**NEW YORK STATE THRUWAY AUTHORITY
DEPARTMENT OF ENGINEERING**

**AMENDMENT NO. 5
TO**

**CONTRACT TANY 26-17B
D215020
REPLACEMENT OF THE PINE HILL ROAD
BRIDGE OVER I-87 AT MP 47.58,
REHABILITATION OF I-87 BRIDGE OVER
SMITH CLOVE ROAD AT MP 47.04,
AND RESURFACING AND SAFETY IMPROVEMENTS
ON I-87 BETWEEN MP 46 AND MP 48
IN THE NEW YORK DIVISION
OF THE NEW YORK STATE THRUWAY
IN ORANGE COUNTY**

**IN THE LETTING OF
JUNE 24, 2026**

TITLE OF PROJECT I-87 BRIDGE REHABILITATION OVER SMITH CLOVE ROAD (MP 47.04)	CONTRACT NUMBER: TANY 26-17B
LOCATION OF PROJECT VILLAGE OF WOODBURY ORANGE COUNTY BIN 5514279	DATE: 05/21/2025
TITLE OF DRAWING WORK ZONE TRAFFIC CONTROL STAGE 3 PLAN (4 OF 4)	DRAWING NUMBER: WZTC-3-04

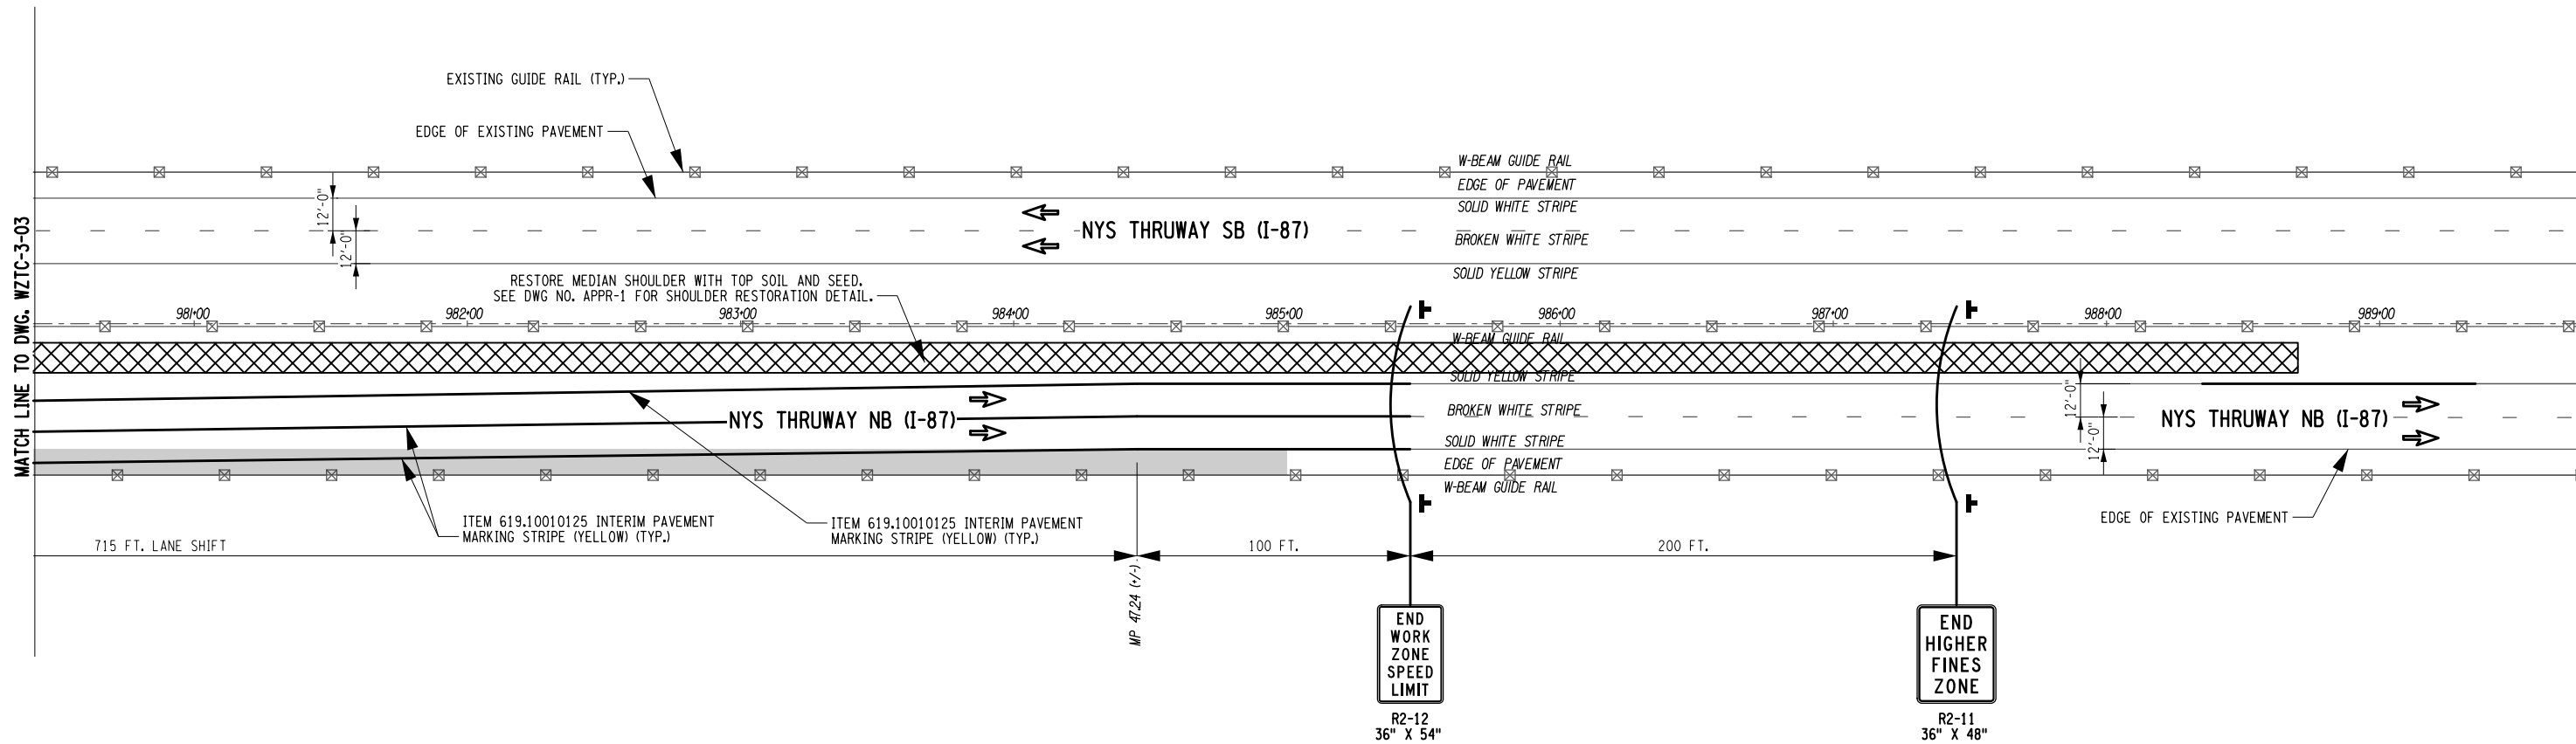
24. **DELETE** Drawing Number WZTC-3-04, Sheet 133 of 180, and **SUBSTITUTE** with the attached Drawing Number WZTC-3-04, Sheet 133A5 of 180. A printing error affecting line styles for Temporary Concrete Barrier, channelizers, and sediment filter logs have been corrected.

TITLE OF PROJECT I-87 BRIDGE REHABILITATION OVER SMITH CLOVE ROAD (MP 47.04)	CONTRACT NUMBER: TANY 26-17B
LOCATION OF PROJECT VILLAGE OF WOODBURY ORANGE COUNTY BIN 5514279	DATE: 05/21/2025
TITLE OF DRAWING TRAFFIC CONTROL PLAN FOR SMITH CLOVE ROAD	DRAWING NUMBER: TCSC-01

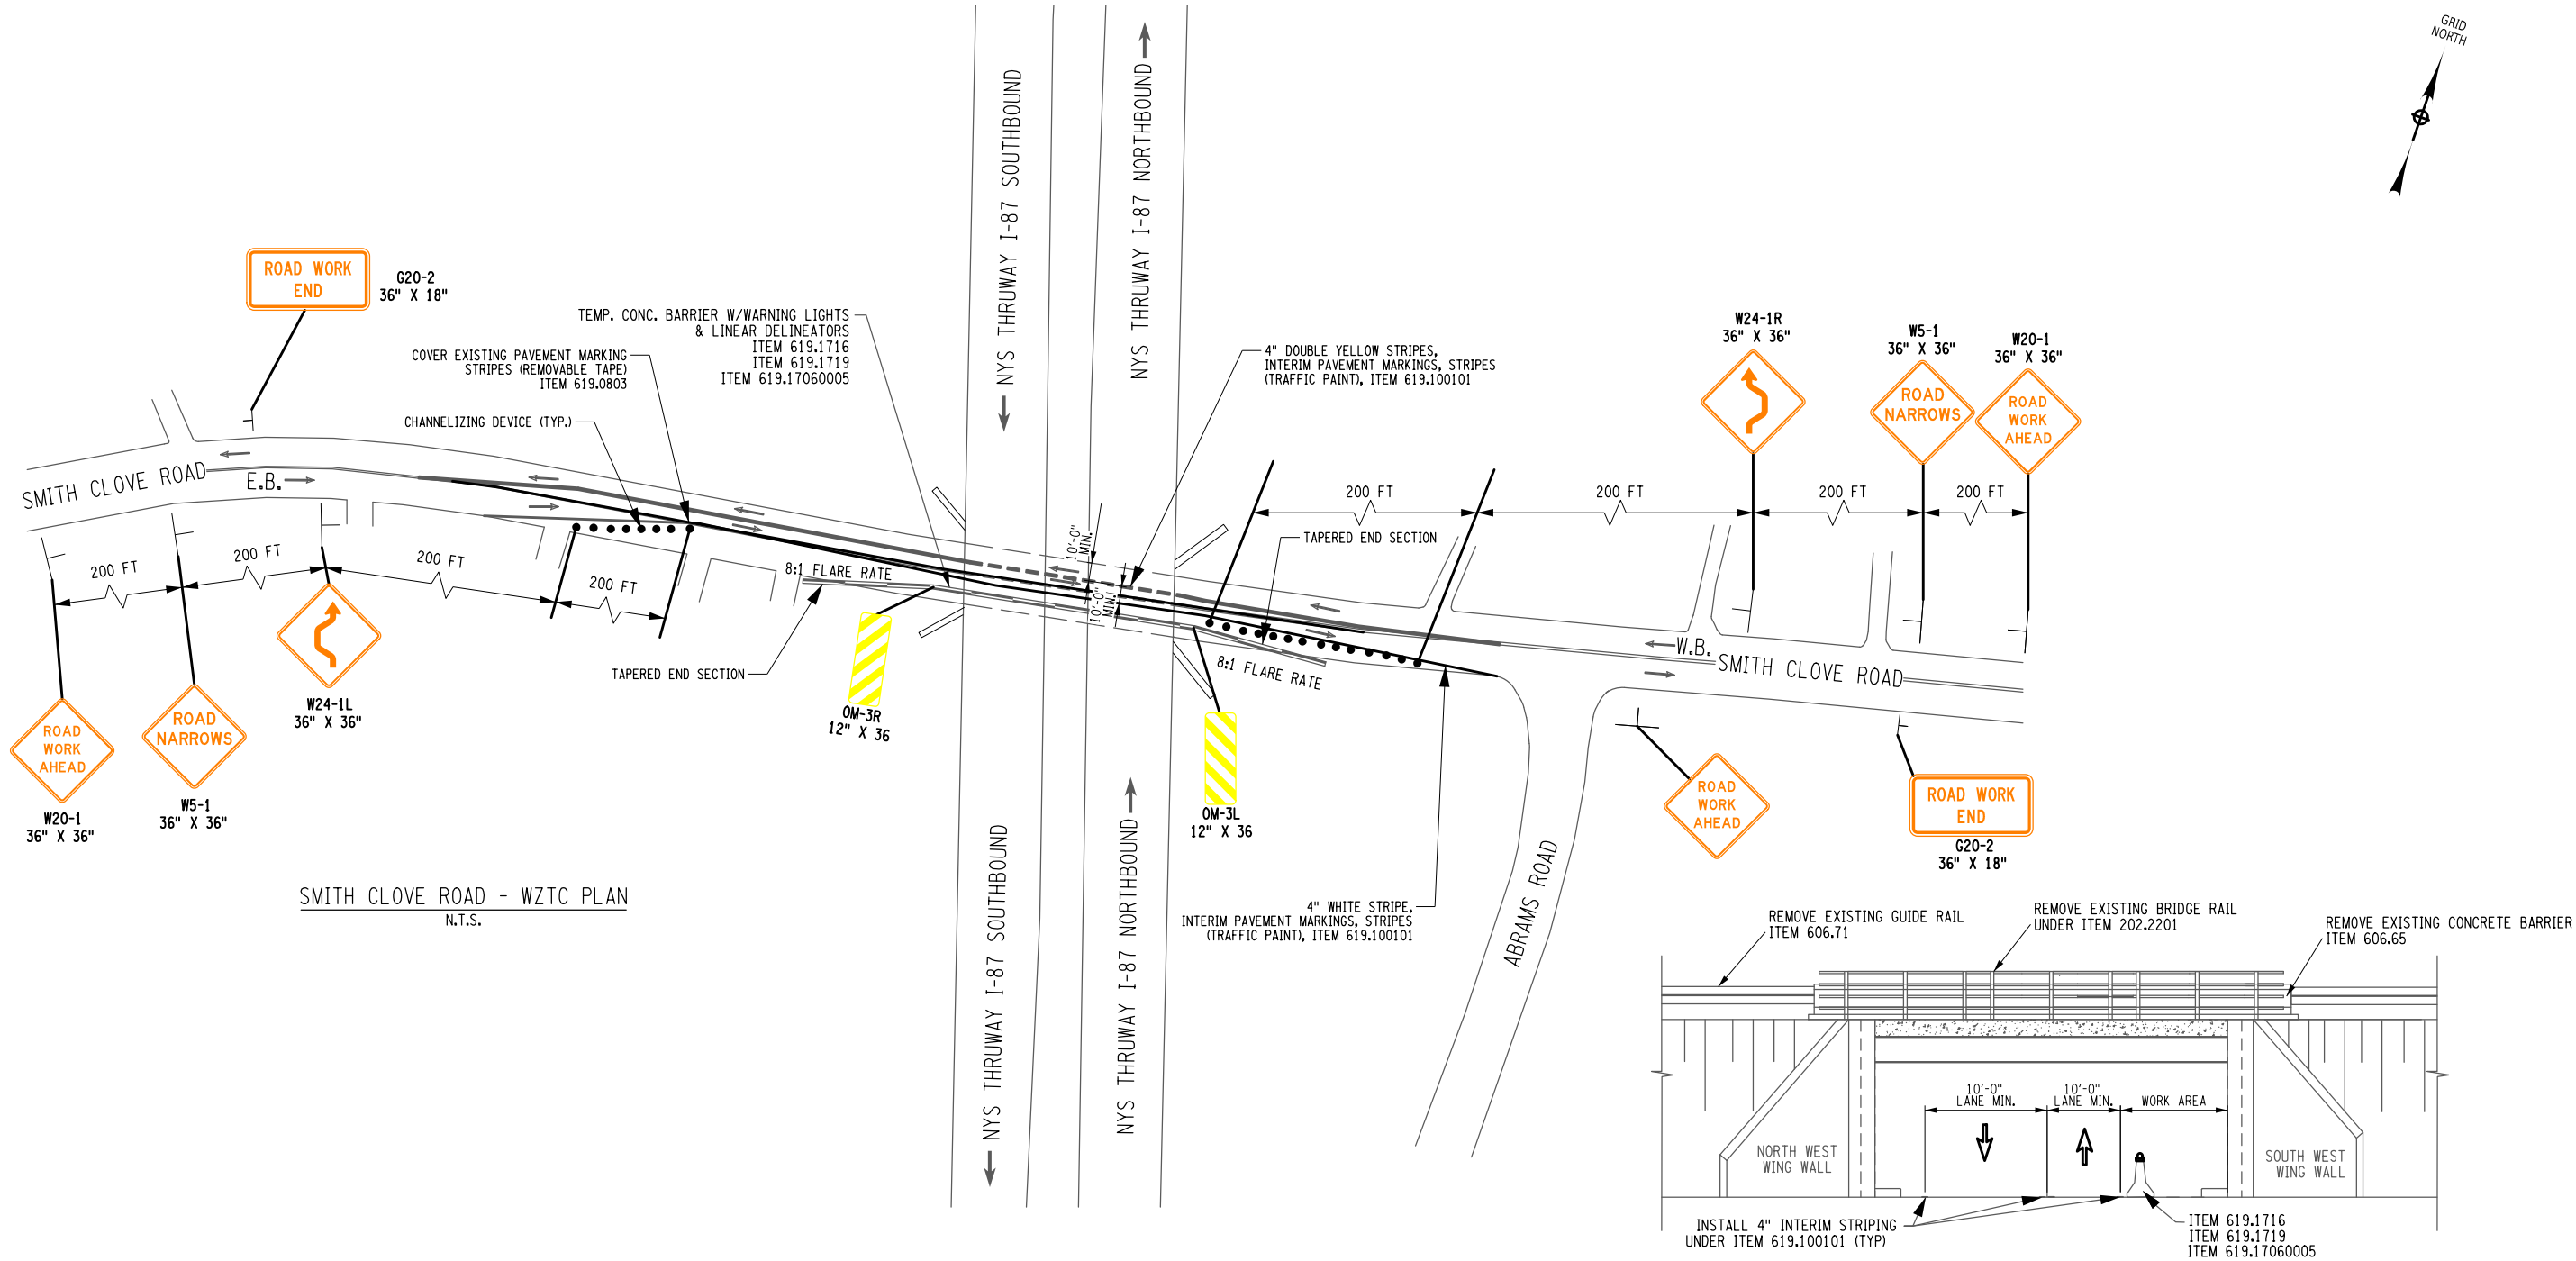
25. **DELETE** Drawing Number TCSC-01, Sheet 134 of 180, and **SUBSTITUTE** with the attached Drawing Number TCSC-01, Sheet 134A5 of 180. In the Smith Clove Road – West View (Elevation The text “(BOTH SIDES)” in the Temporary callout had been removed.
